# UNITED STATES PATENT AND TRADEMARK OFFICE

APPLICATION NO.	FILING DATE	FIRST NAMED INVENTOR	ATTORNEY DOCKET NO.	CONFIRMATION NO.
10/624,559	07/23/2003	Masaharu Nishikawa	50195-375	6633

<b>Office Action Summary</b>	<b>Application No.</b>	<b>Applicant(s)</b>	
	10/624,559	NISHIKAWA, MASA HARU	
	<b>Examiner</b>	<b>Art Unit</b>	
	Katherine W. Mitchell	3677

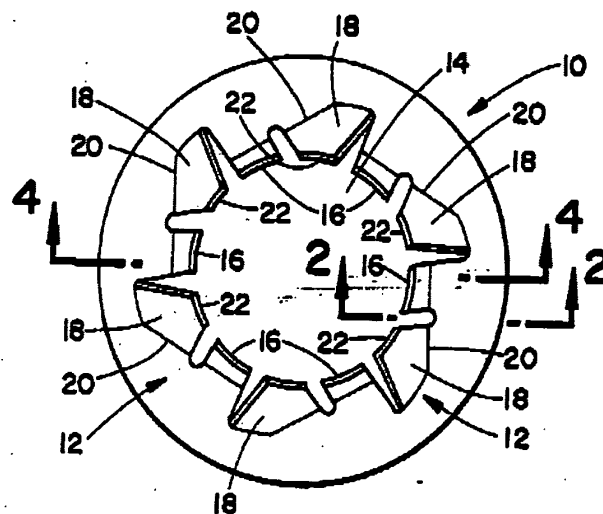
- A clip body 12 with an abutment part capable of attaching a first member to a second member, having a shank hole to accommodate passage of a bolt
- A plurality of engagement claws (spring fingers 18 and 16 are both considered claws, per Fig 4 and col 3 lines 51- col 4 line 41) formed around inner periphery of hole and radially projecting inward (Fig 1) and inclined to the clip body so that the respective tips depart in an axial direction from clip body, thereby providing claws as a whole a substantially cone-shaped configuration (Fig 3)
- Wherein engagement claws are capable of engaging bolt shank while urging first member toward second member along bolt axial direction (see Fig 4 below, and

col 3 lines 39- col 4 line 48)

- Wherein engagement claws include at least 2 specific claws adjoining in circumferential direction (Fig 1, adjacent claws 16 and 18, see Fig 1 below)

- Wherein the tips of two specific claws are apart from each other a predetermined distance in height (Fig 4, 18 higher than 16) and the height difference is equal to one or more thread pitches on the bolt shank.
- Examiner notes that Fisher teaches in col 1 lines 8-18 that the clips are commonly used to retain partial assemblies in an assembled relationship, thus inherently there are first and second members attached by the clip via a bolt.
